EPC STORMWATER REVIEW COMMENTS
IN ORANGE BOXES WITH BLACK TEXT

PRELIMINARY SITE GRADING CONSTRUCTION PLANS
FOR
THE RIDGE AT LORSON RANCH
EARLY OVERLOT GRADING / EROSION CONTROL PLANS

PROJECT:
THE RIDGE AT LORSON RANCH
FONTAINE BLVD, WALLEYE DR
COLORADO SPRINGS, COLORADO

COVER SHEET
EARLY GRADING AND
EROSION CONTROL PLAN

SHEET NUMBER **C4.7**

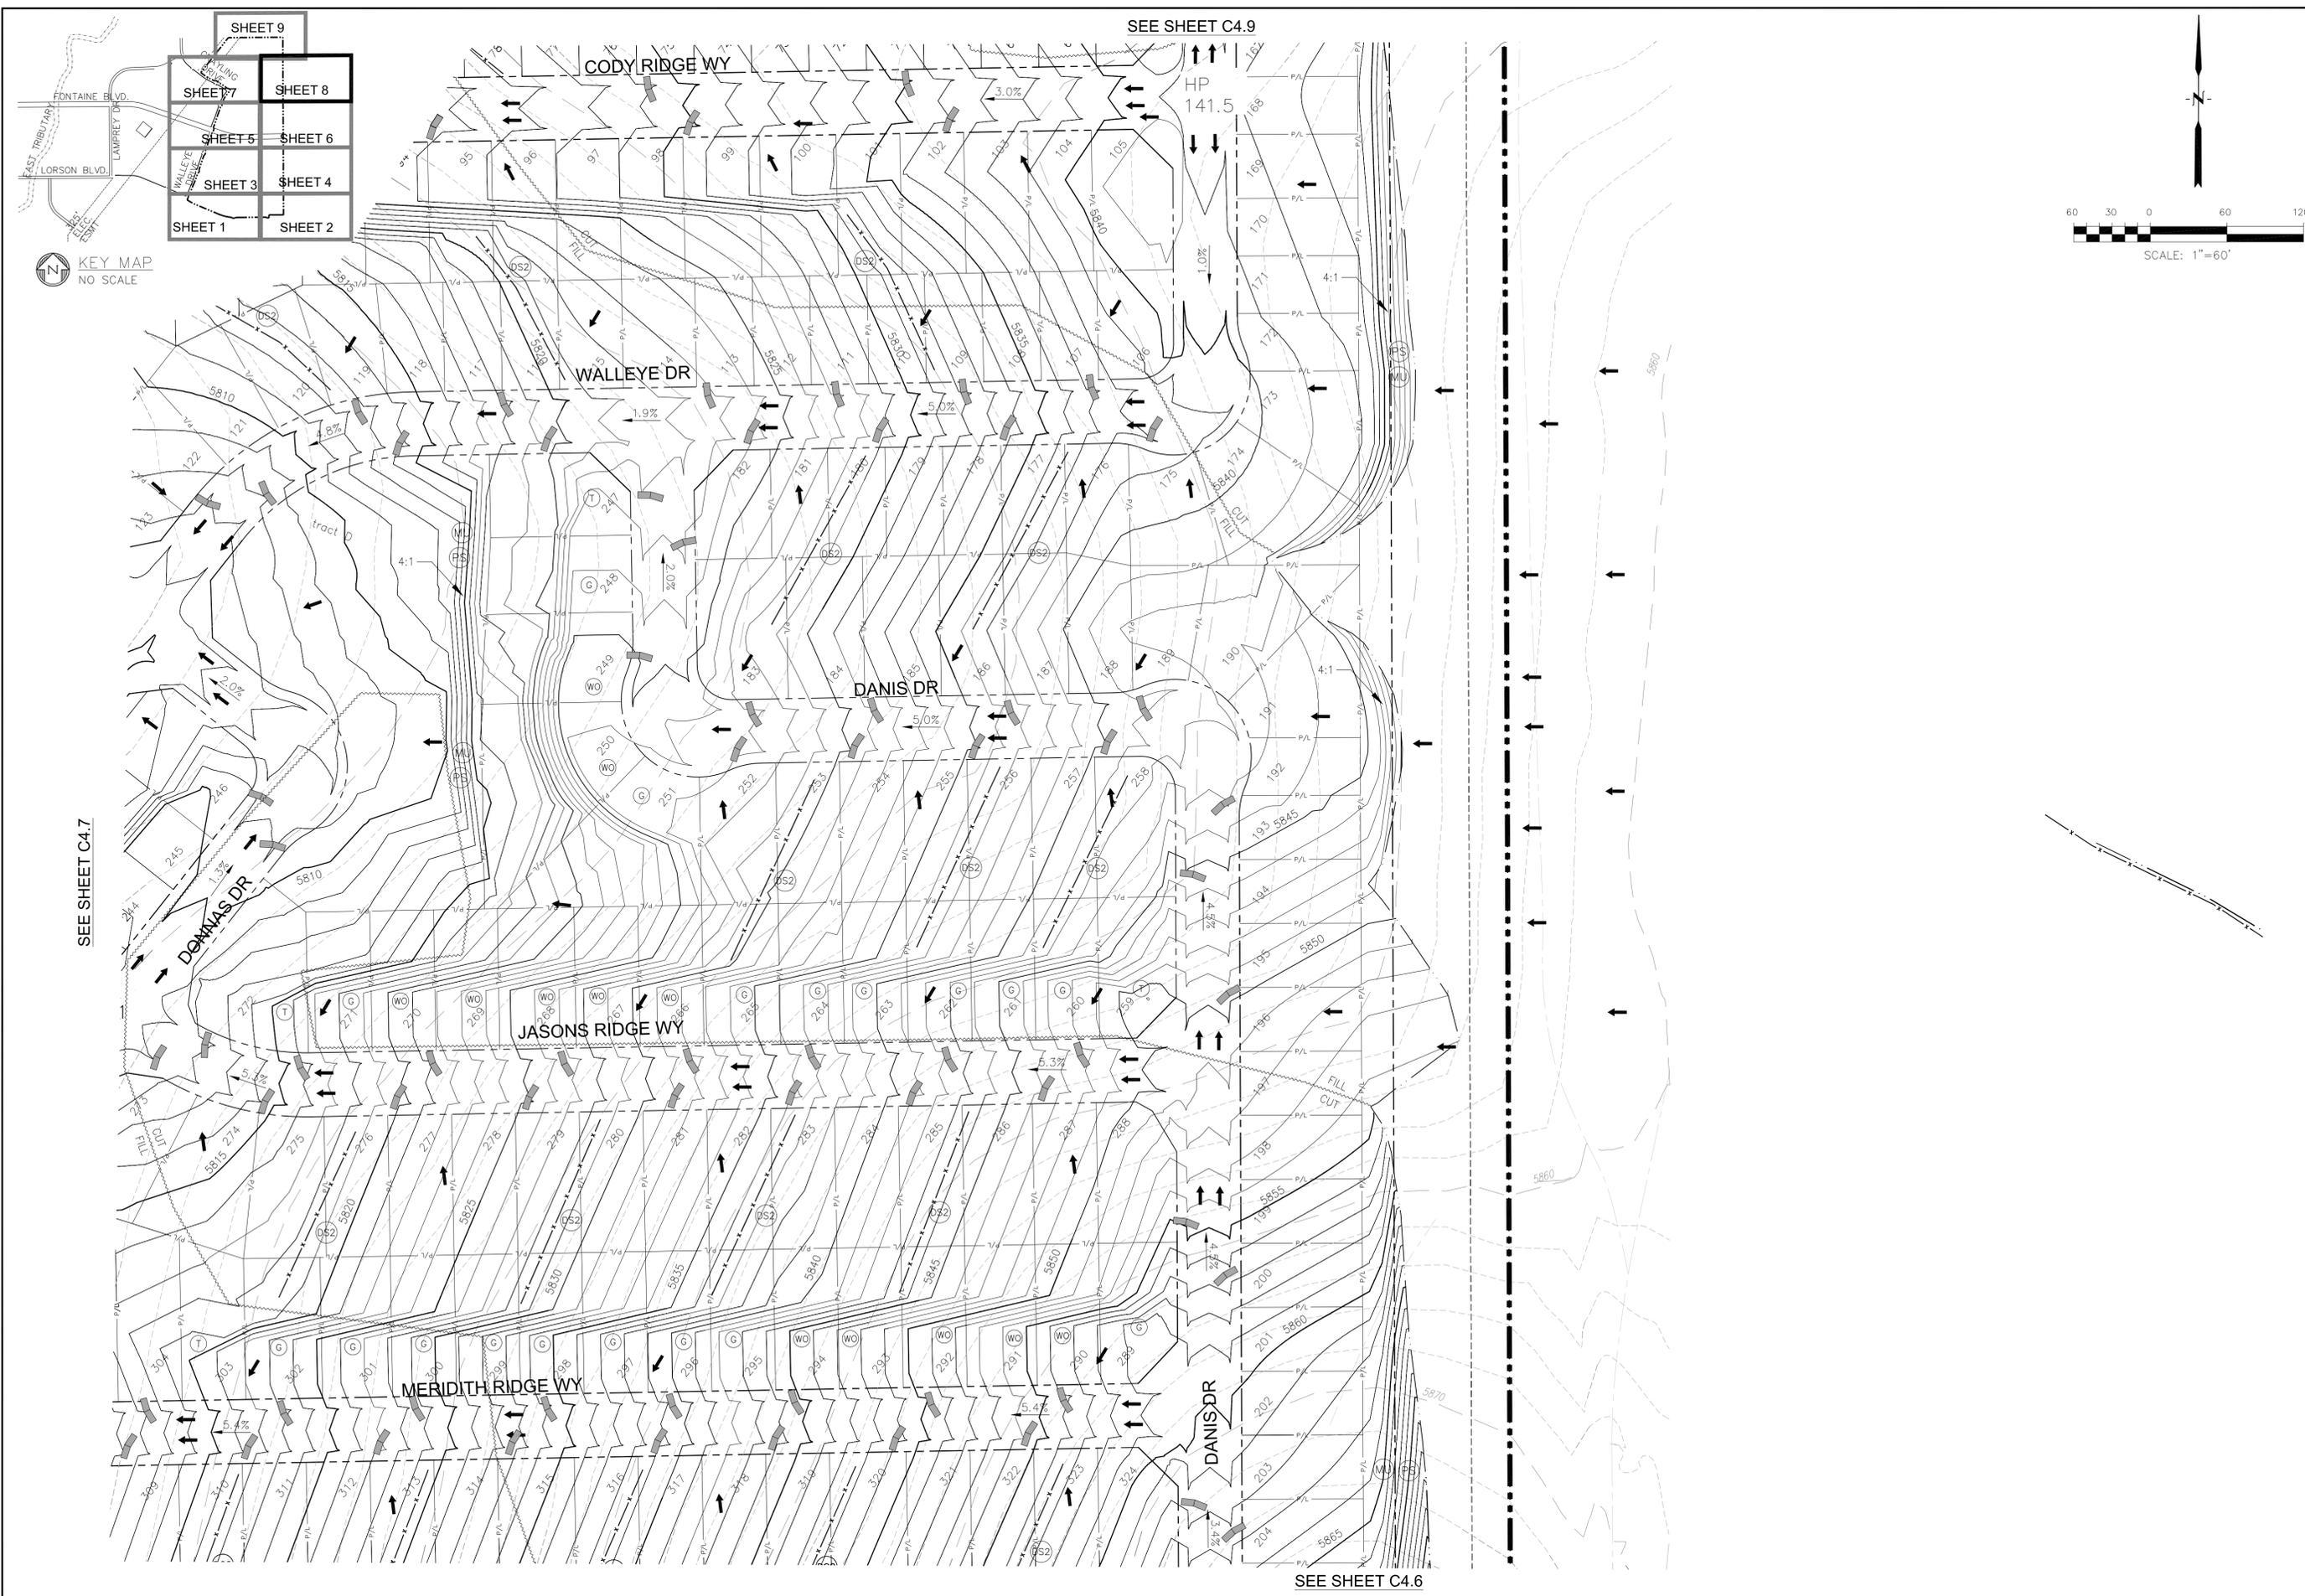
Sediment traps are not sufficient for this application. According to MHFD Detail SC-8, they are for disturbed tributary areas <1ac. For >1ac, a sediment basin is more appropriate. Calculate and show approx tributary area.

SHEET NUMBER C9.1

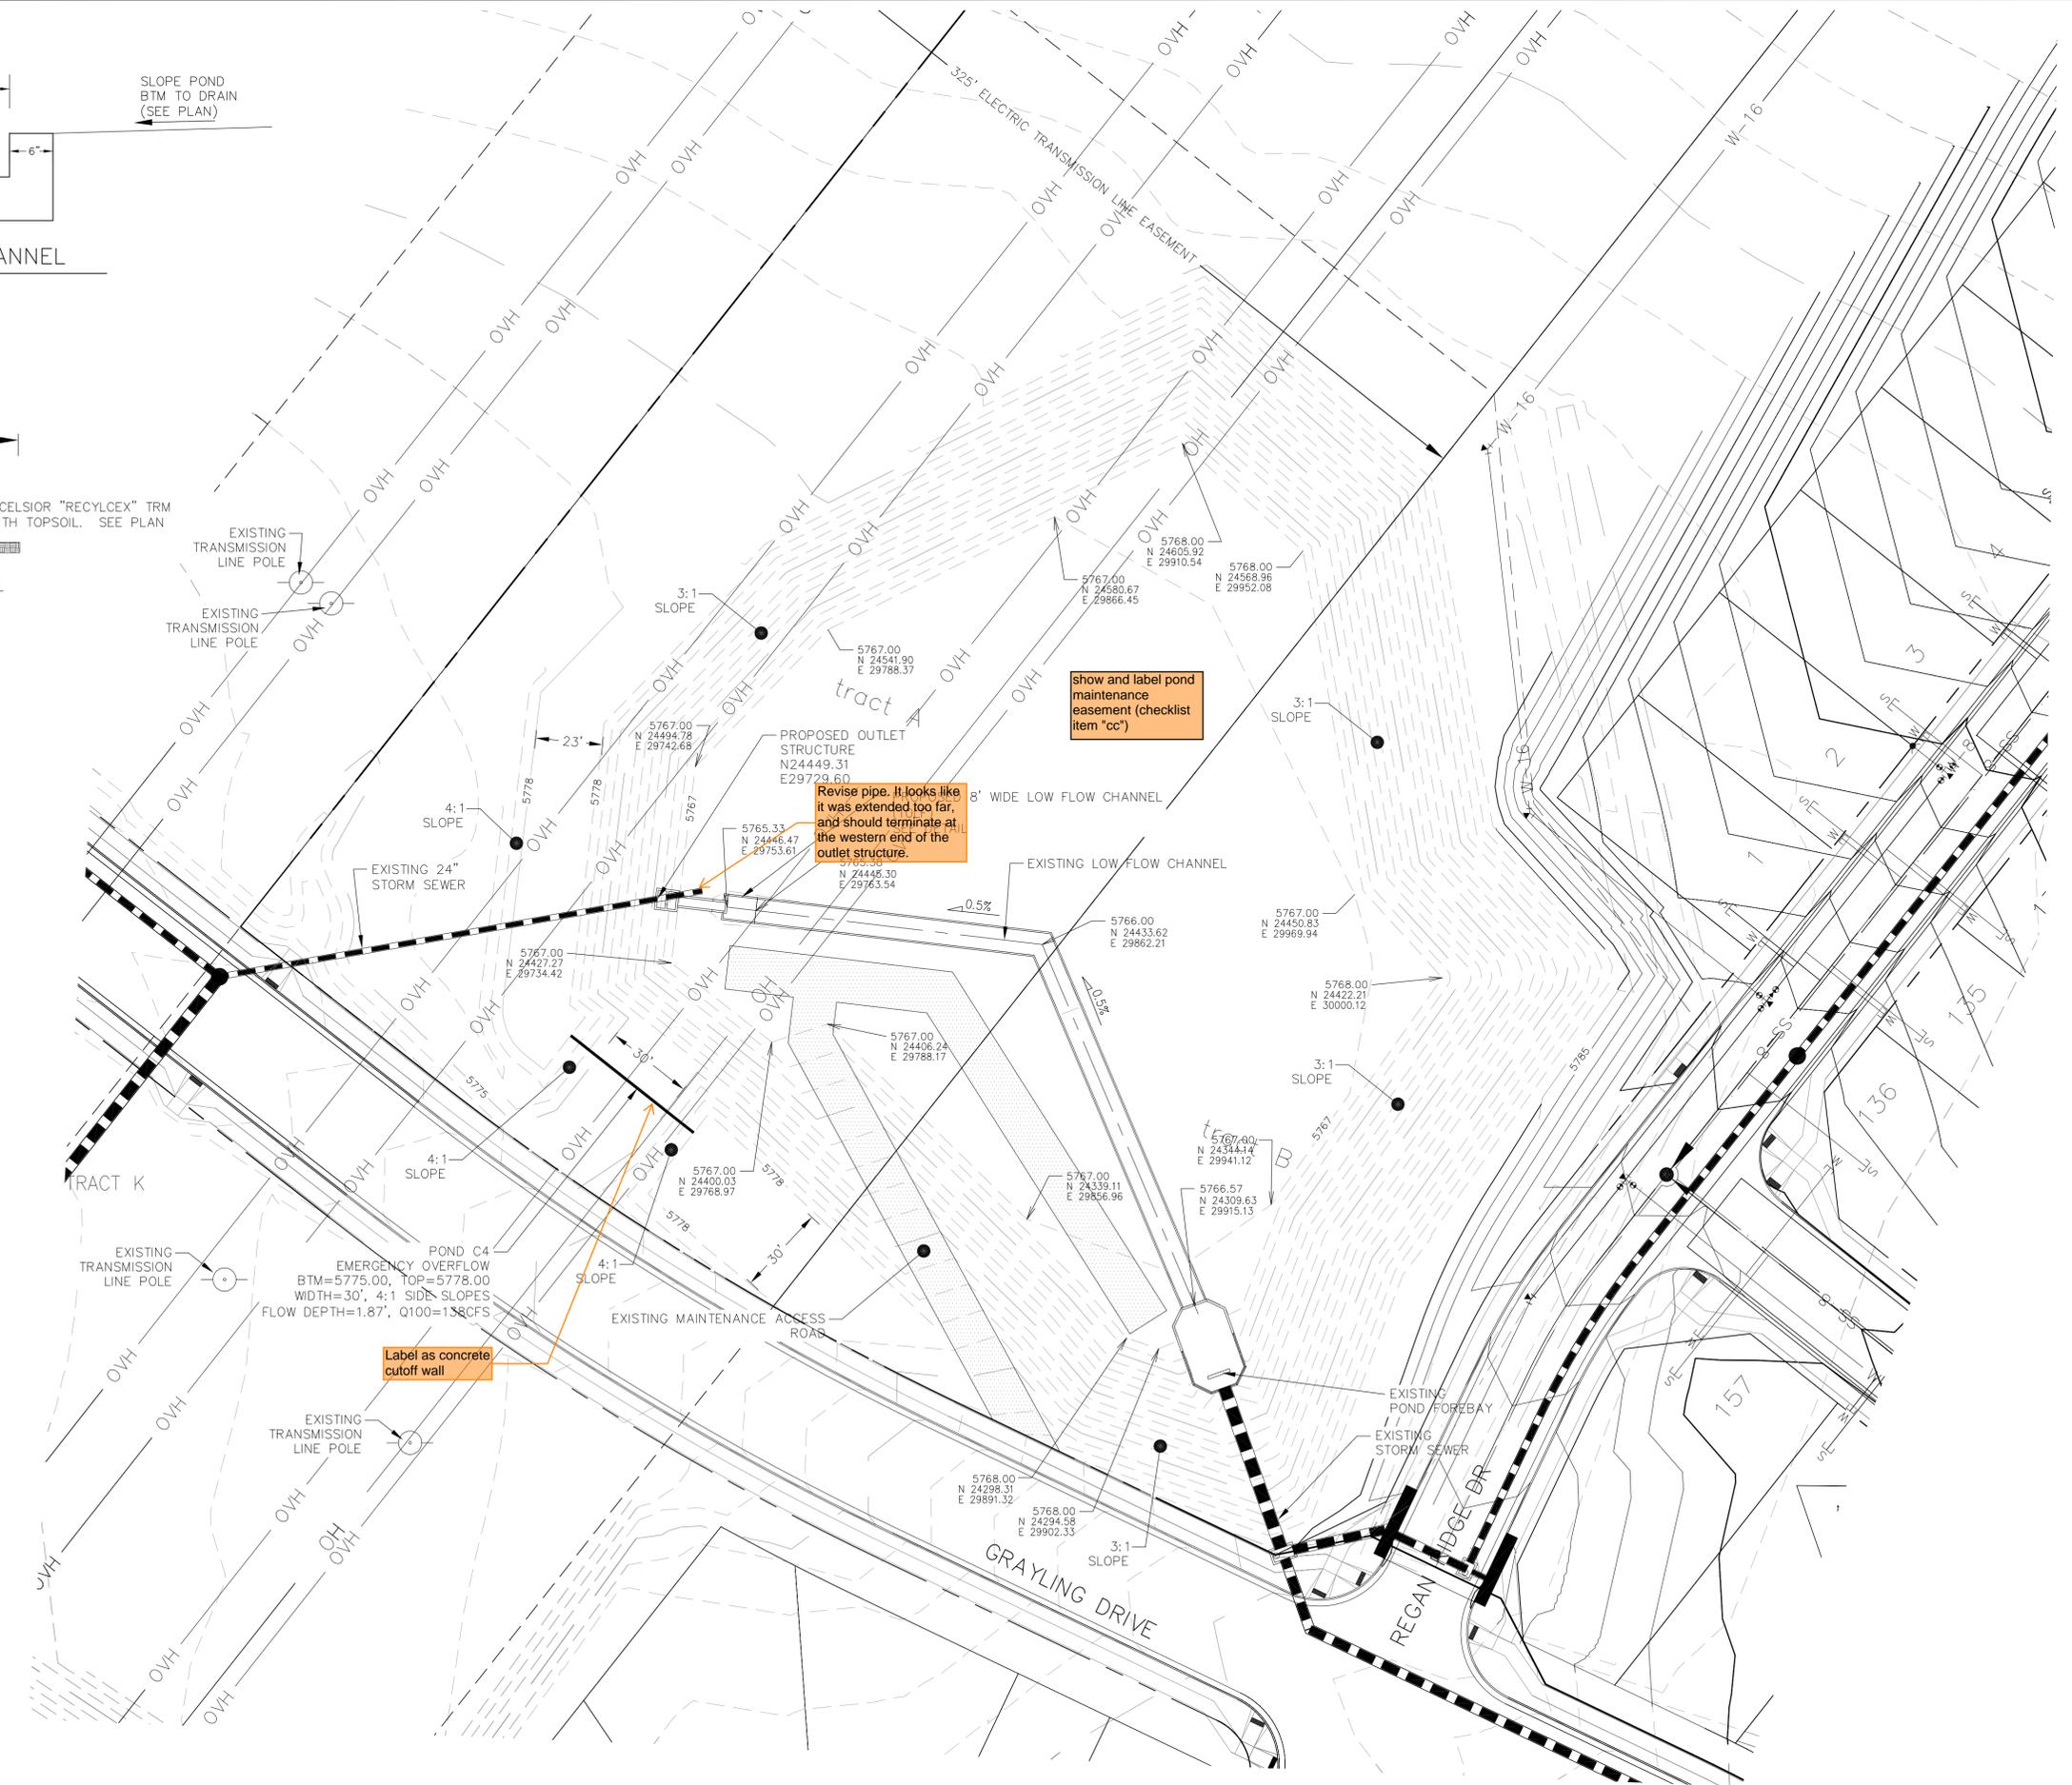
show and label pond maintenance easement (checklist item "cc")

Revise pipe. It looks like it was extended too far, and should terminate at the western end of the outlet structure.

Label as concrete cutoff wall

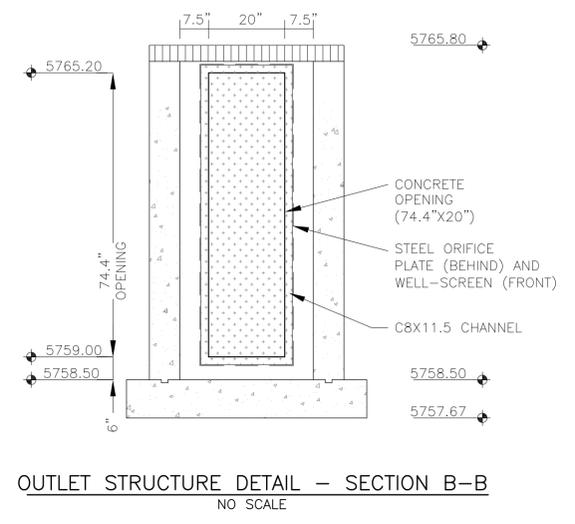
Appears to be 2 different types of well screens. Revise text to clarify.

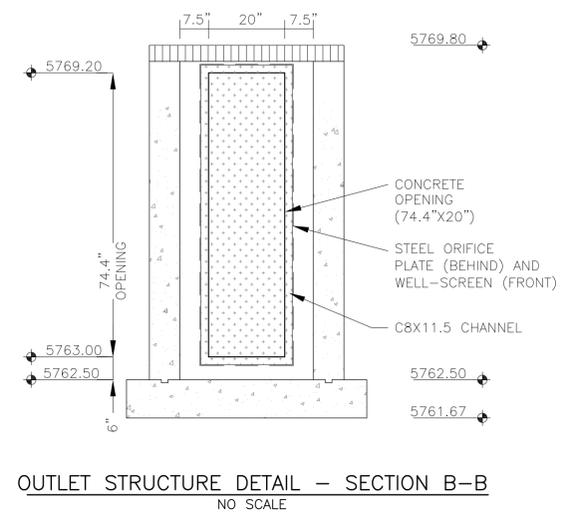
Appears to be 2 different types of well screens. Revise text to clarify.

ST-8 Sediment Trap (ST) November 2010

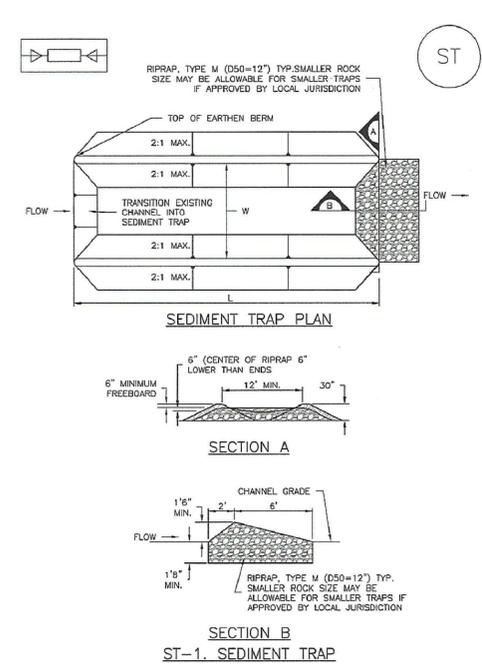
Not listed on FAE. So likely not used on plans (although it's in the Legend)? If true, then you don't need this detail.
